REPORT OF FINDINGS
OF THE
EQUUS BEDS GROUNDWATER RECHARGE PROJECT

OF THE
CITY OF WICHITA
WATER & SEWER DEPARTMENT

CARL E. NUZMAN, P.E., P.Hg.
Consulting Engineer/Hydrogeologist
3314 NW Huxman Road
Silver Lake, Kansas 66539-9243

June 29, 2004

DISTANCE-DRAWDOWN

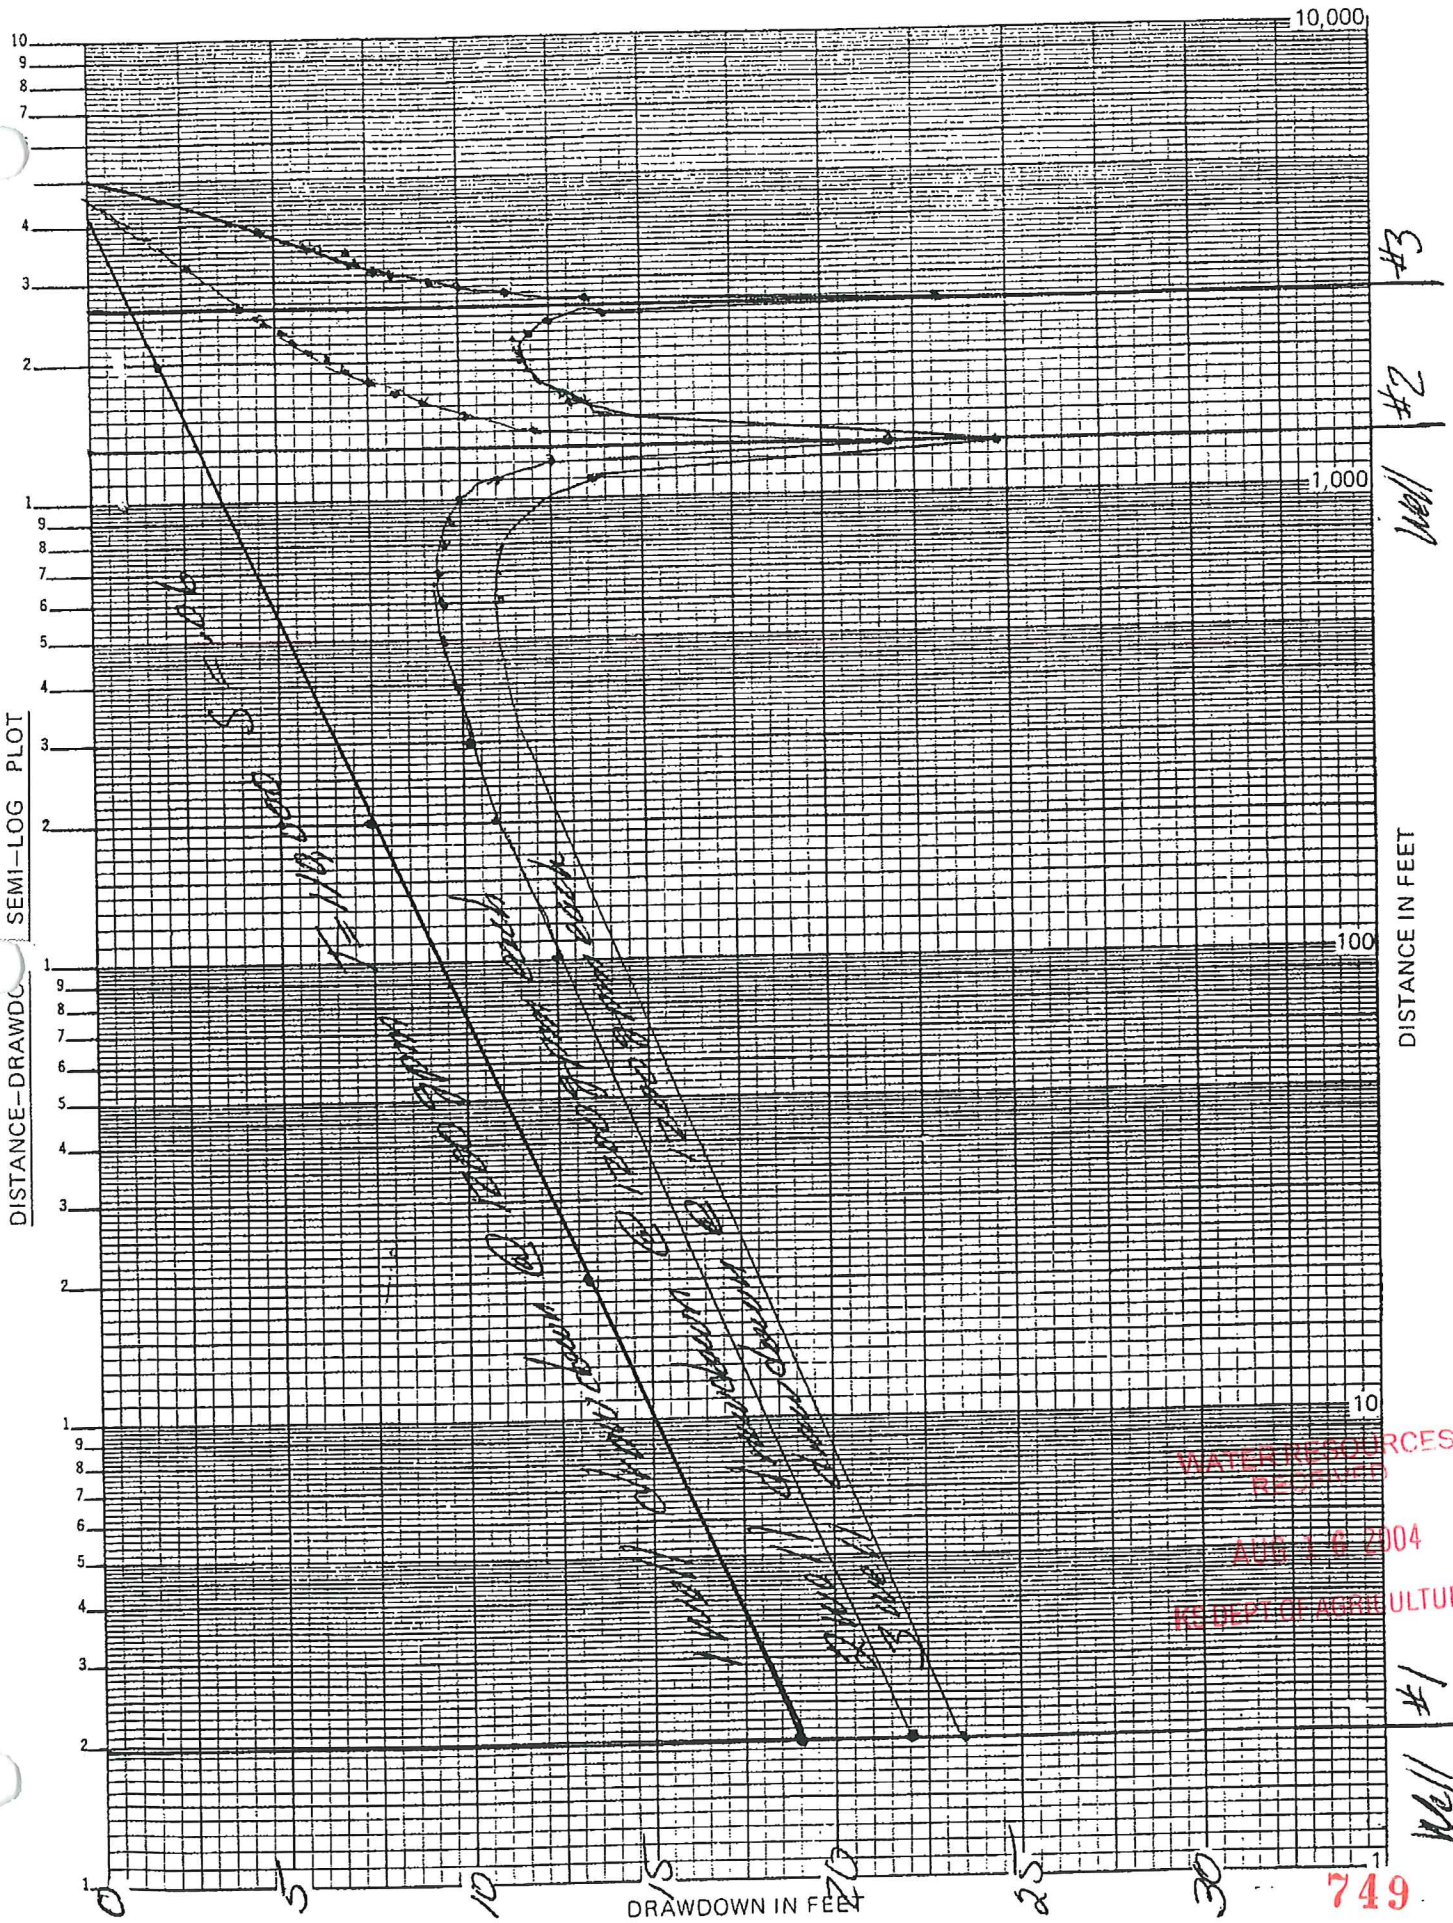
3.6.5 The drawdown shall not exceed about 10 feet below the normal base level ground water level established at a distance of 660 feet from any source water recharge well in a general westerly direction in either aquifer. Further the combined drawdown from any or all source water recharge wells when operating shall not exceed 7 feet below normal base ground water levels in either aquifer at approximately ½ mile in any direction at any time.

Proposed Hydraulic Barrier Wells Locations

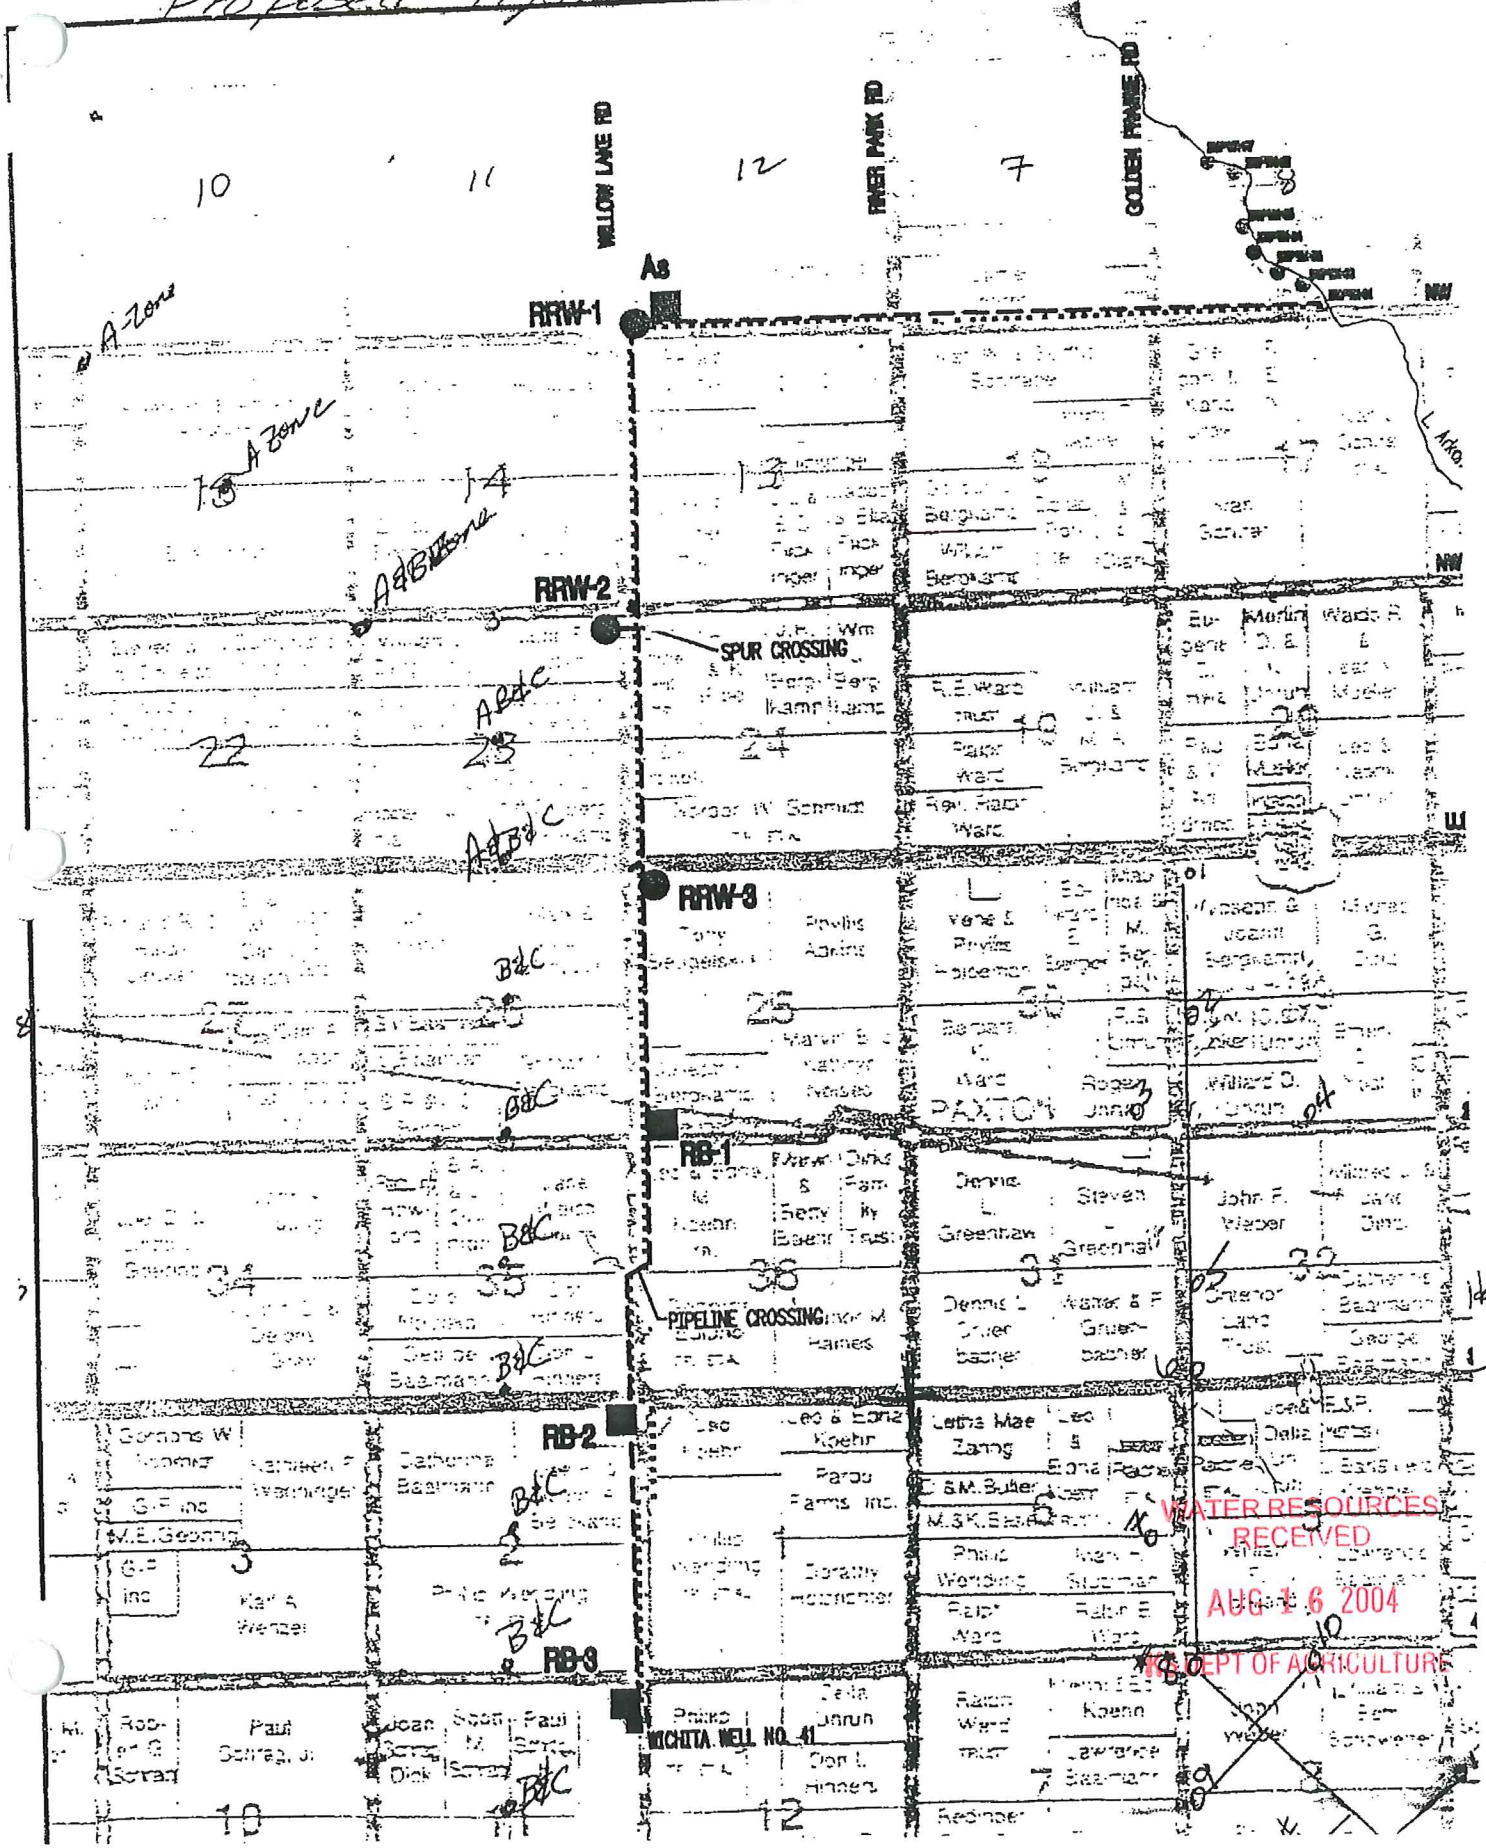
5.2.3 If the intent of the project is to completely halt the movement of the Burrton Area high chloride water and hold it in its present position, then a modification to initial proposed program of the aquifer recharge and recovery wells (RRW's) is needed. To develop a hydraulic barrier at the down-gradient edge of the plume, it is proposed that a series of injection wells only be installed beginning at the NW corner of Section 15, T-23-S, R-3-W, penetrating the A-zone of the aquifer, and proceeding southeast diagonally across Section 15 to the center of Section 23 where penetration of the full thickness of the aquifer is needed, then south to the middle of Section 11 in the vicinity of Wichita Well No. 41, penetrating the B and C zones of the aquifer. As much as 75 percent to 90 percent of the injected water in the proposed hydraulic barrier wells can be captured by down gradient wells such as those proposed along Willow Lake road. Details of the design for the hydraulic barrier wells will be furnished upon request.
